Proposal for SAS 2.x Specification to Enable Support for Active Cables

Gourgen Oganessyan

May 2, 2008

Figure 98 — Mini SAS 4x cable plug connector that attaches to an enclosure universal port

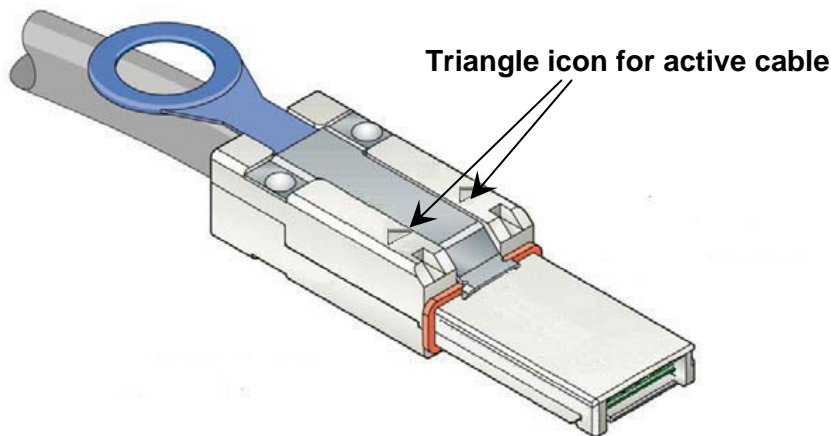
In order to ensure that active cables cannot be plugged into legacy (passive) ports, differentiating keying shall be provided by removing all the key slots from the plug connector and all the keys on the receptacle connector. In addition, two triangle icons on each side on the plug connector will be added to the plug connector to distinguish an active cable assembly (Figure 98).

Figure 98 shows an active mini SAS 4x cable plug connector that attaches to an enclosure universal port:
